MC68307

Errata to MC68307 Integrated Multiple-Bus Processor User Manual

Tues, 25th July 1995.

Figure 3-12. 8051-Compatible Read Cycle Signals

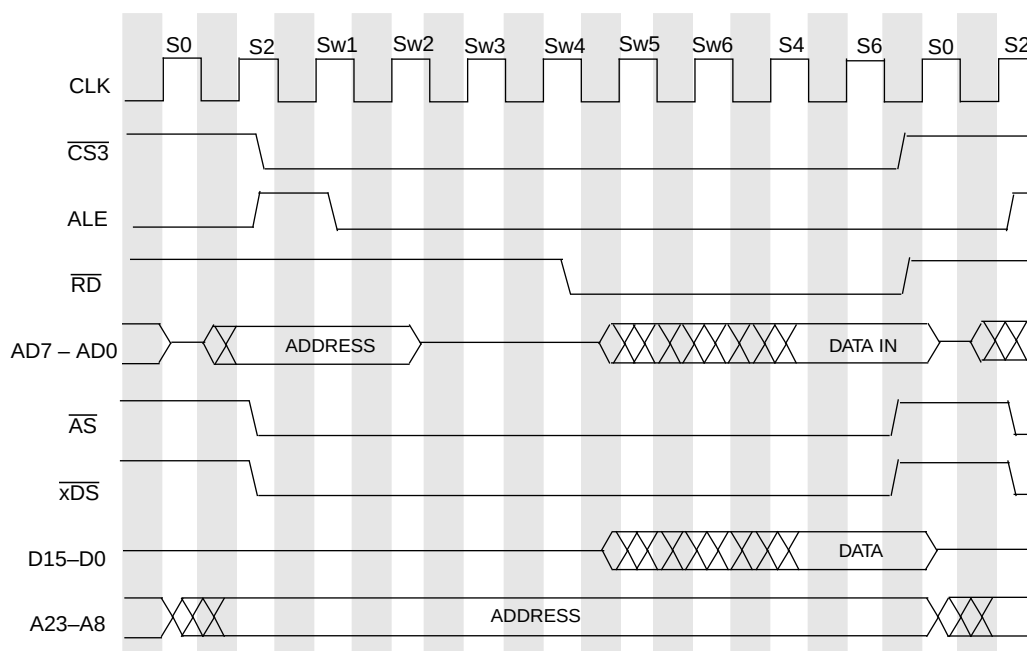
p. 3-14: Section 3.1.7., 8051-Bus Operation. The 8051-compatible read and write cycles should be as follows:

11-13. Port Timing

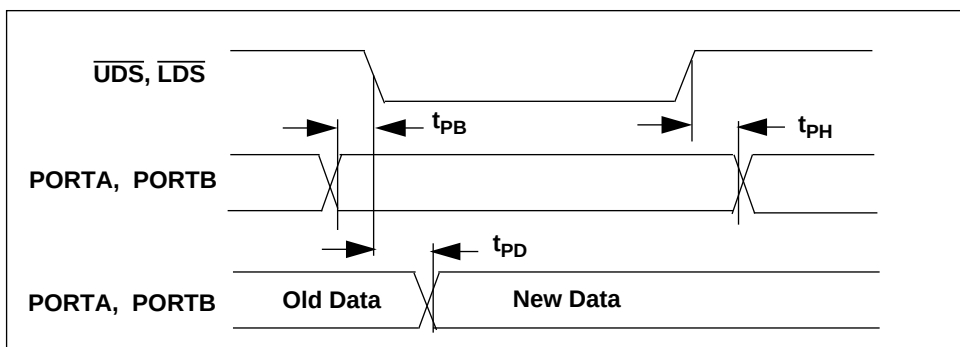
p. 11-16: Section 11.14, AC Electrical Characteristics - Port Timing. The 8MHz and 16.67MHz timing values should be changed and the tPD time referenced to UDS/LDS assertion as follows:

Characteristic	Symbol	3.3V		3.3 V or 5 V		Unit
		8.33 MHz		16.67 MHz		
		Min	Max	Min	Max	
Port Input Setup Time to $\overline{UDS}$, $\overline{LDS}$ Asserted	tPS	0	—	0	—	ns
Port Input Hold Time from $\overline{UDS}$, $\overline{LDS}$ Negated	tPH	0	—	0	—	ns
Port Output Valid from $\overline{UDS}$, $\overline{LDS}$ Asserted	tPD	—	20	—	10	ns

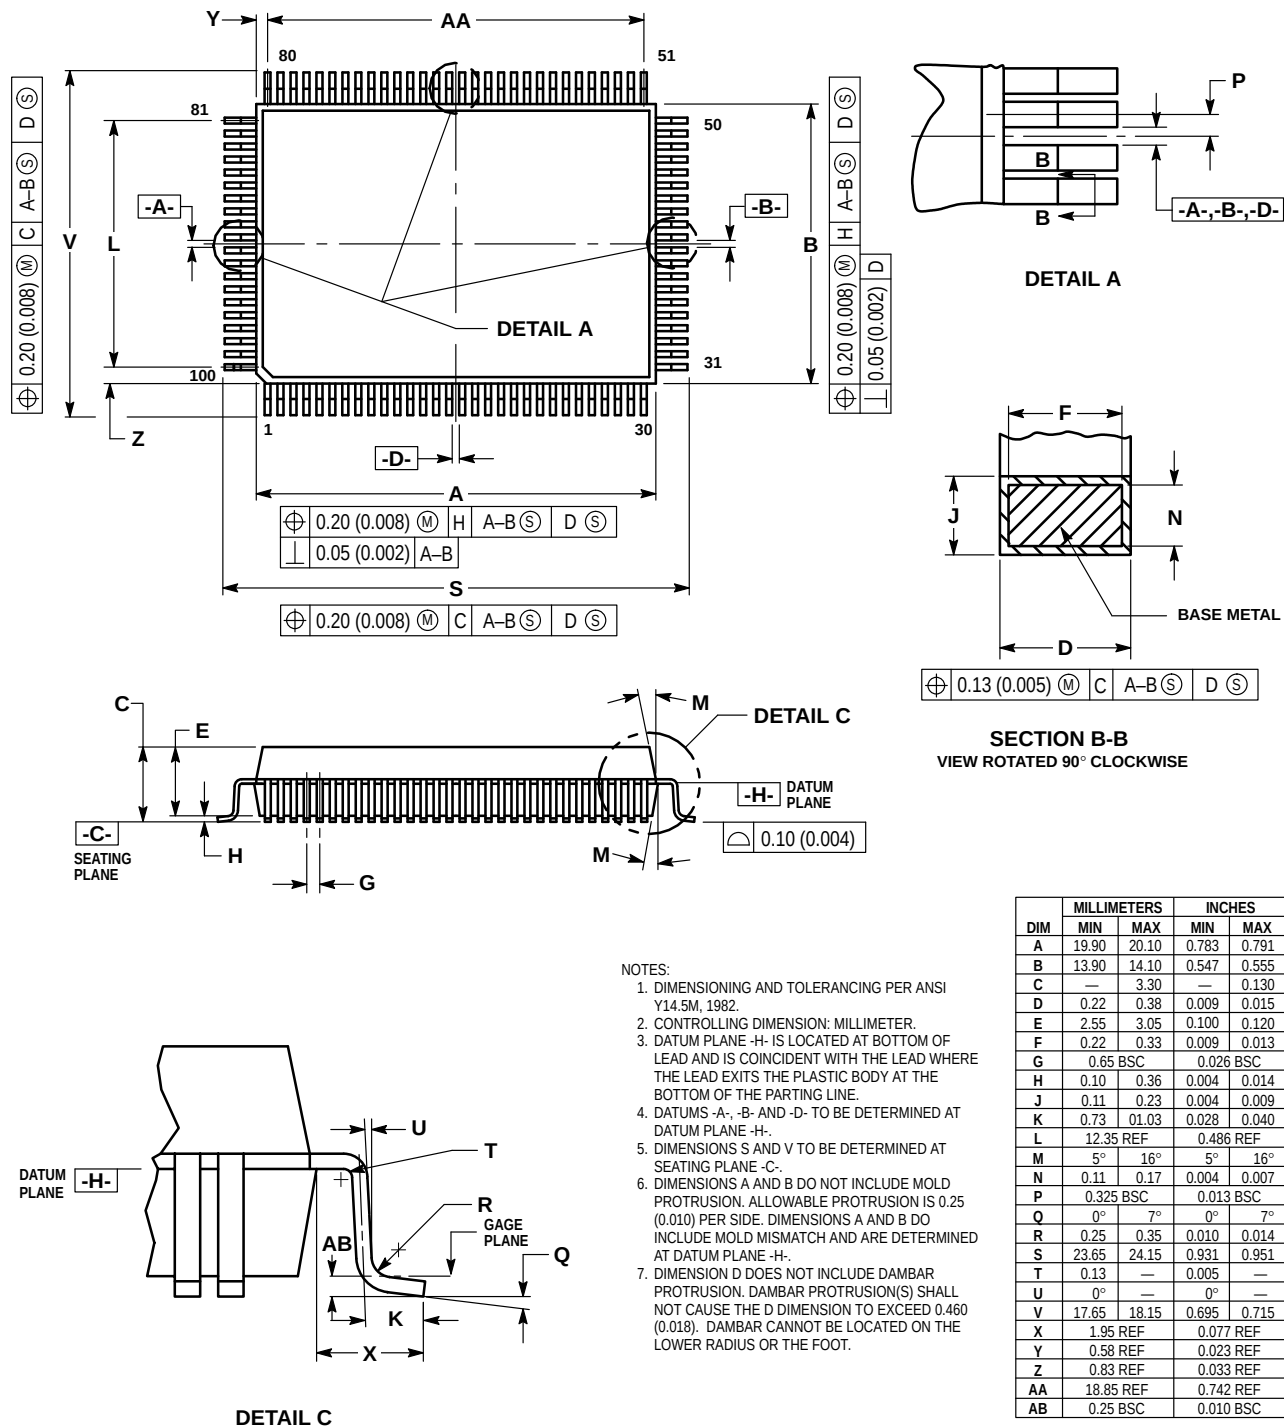
This package replaces the one shown on page 12-3 of the MC68307 User's Manual.
